MODELS AFFECTED: 407

SUBJECT: DOOR LATCH ASSEMBLIES P/N 20898-401, -402, -405 AND -406, MODIFICATION OF.

HELICOPTERS AFFECTED: 407, Serial Numbers 53000 through 53228.

Figure 1. (Sheet 1 of 2)

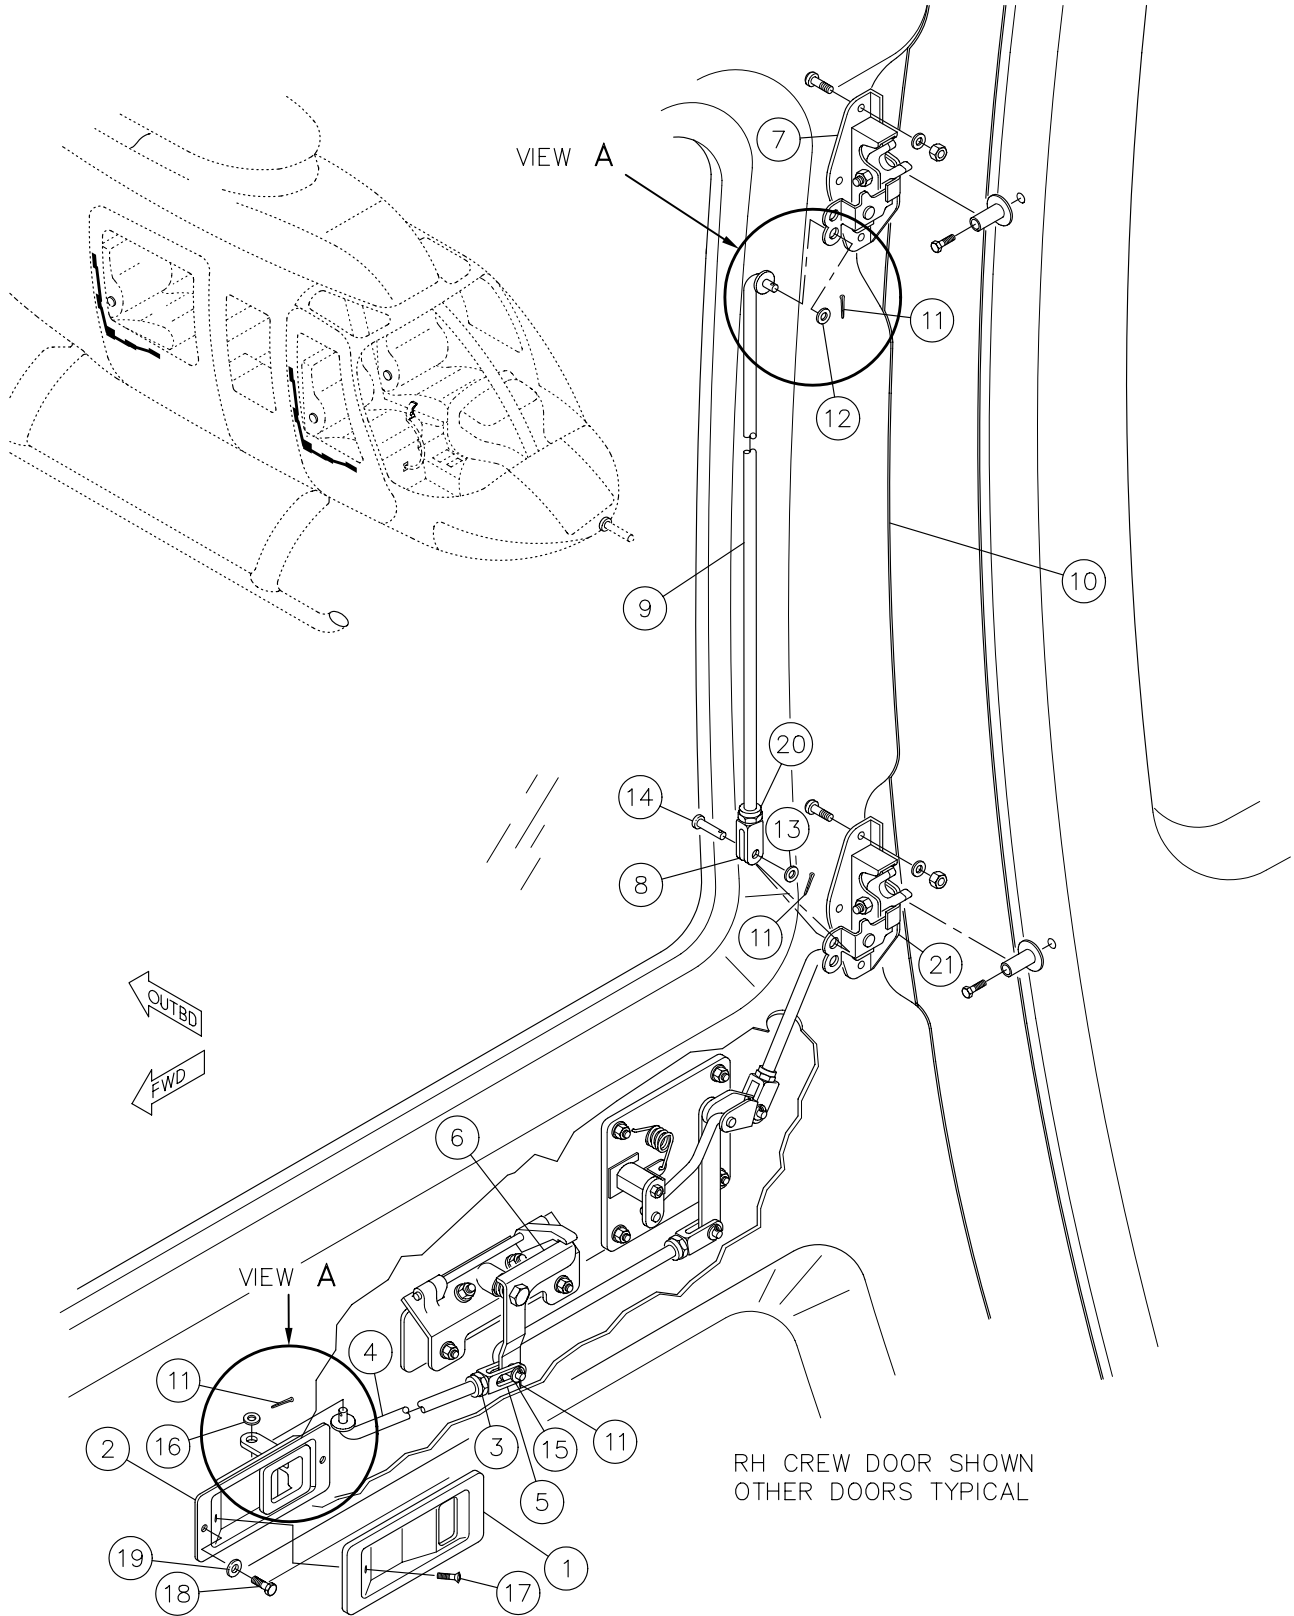
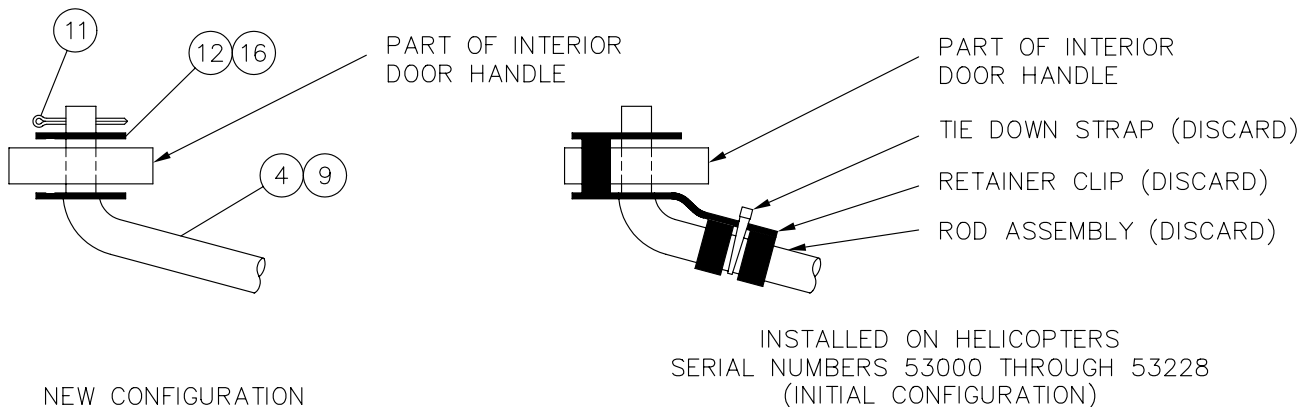
DESCRIPTION: Bell Helicopter was sent reports that rod assemblies accidentally disengaged from the door handle. The person in the helicopter could then not open the door. This Alert Service Bulletin is sent to make a modification to the attachment of two rod assemblies in each crew and passenger door latch assembly.

Do the steps that follow to replace the rod assemblies on all crew and passenger doors:

1. Get access to the interior door handle (2, Figure 1).
2. Remove the screws (18) and washers (19) that attach the interior door handle (2) to the door structure (10).

3. Disconnect the rod assembly (4) from the bellcrank (6).
4. Pull out the interior door handle (2) to permit access to the rod assembly (4) that is connected to the interior door handle (2). Remove the tie down strap and the clip (View A) that attach the rod assembly (4) to the handle. Disconnect the rod assembly (4) from the interior door handle (2). Discard the clip.

8. Connect the clevis end of the new rod to the bellcrank (6) with the initial hardware, but use a new cotter pin.
9. Connect the bent end of the new rod assembly to the interior door handle (2) with the washer (16) and cotter pin (11). Make sure that the cotter pin (11) is bent so that it cannot catch on adjacent parts of the latch or door.

11. Get access to the upper door latch area.
12. Remove the tie down strap and the clip (View A) that attach the rod assembly (9) to the upper latch assembly (7).

17. Connect the clevis end of the new rod to the lower latch assembly (21) with the initial hardware, but use a new cotter pin.
 18. Connect the bent end of the new rod assembly to the upper latch assembly (7) with the washer (12) and the cotter pin (11). Make sure that the cotter pin (11) is bent so that it cannot catch on adjacent parts of the latch or door.

NEW ROD ASSEMBLY APPLICATION

④	ROD ASSEMBLY	CREW	PASS.
		L.H.	3164-220
	R.H.	3164-219	3164-221

⑨	ROD ASSEMBLY	CREW	PASS.
		L.H.	3164-217
	R.H.	3164-217	3164-217
